TO: Advisory Board on Radiation and Worker Health Work Group on TBD-6000  
FROM: Robert Anigstein and John Mauro, SC&A  
SUBJECT: Review of Appendix BB, Revision 1  
DATE: October 29, 2014

## **Review of “Site Profiles for Atomic Weapons Employers that Worked Uranium Metals Appendix BB – General Steel Industries,” Revision 1**

Figure 1. Detail from Plant Layout, Showing Betatron Buildings (GSCC 1969)

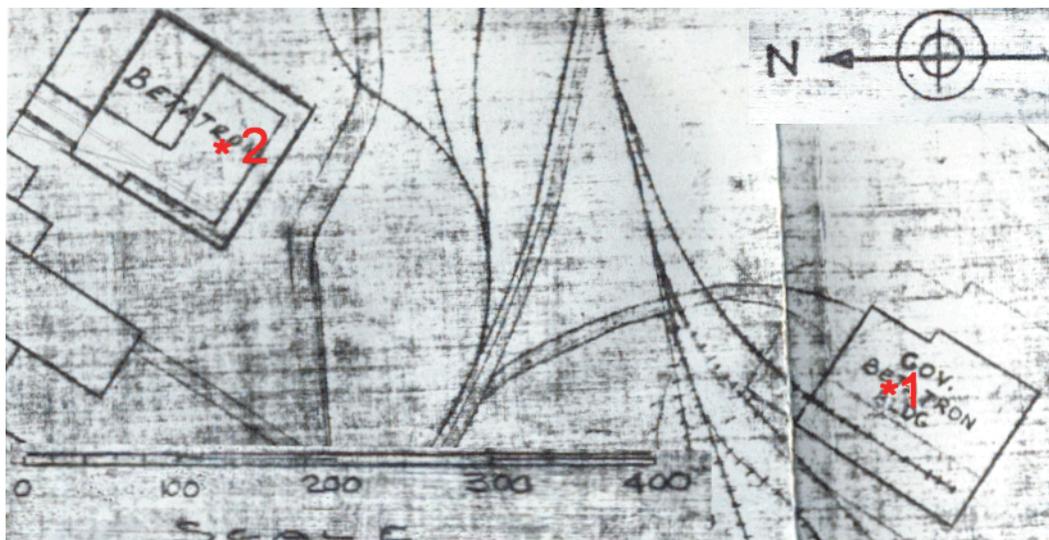
This conclusion is further bolstered by the fact that the limiting scenario for external exposure during 1963–1966, the years during which both betatrons were operating, is the layout man. In this scenario, the worker is assumed to be located just outside the New Betatron Building, in the area shown in the upper-left-hand corner of Figure 1. Any neutrons from the old betatron reaching this location would be attenuated by passing through the southwest shield wall of the New Betatron Building, in addition to being greatly reduced by the distance. We nevertheless recommend that the revised Appendix BB should take note of this potential contribution to resolve any questions regarding this issue.
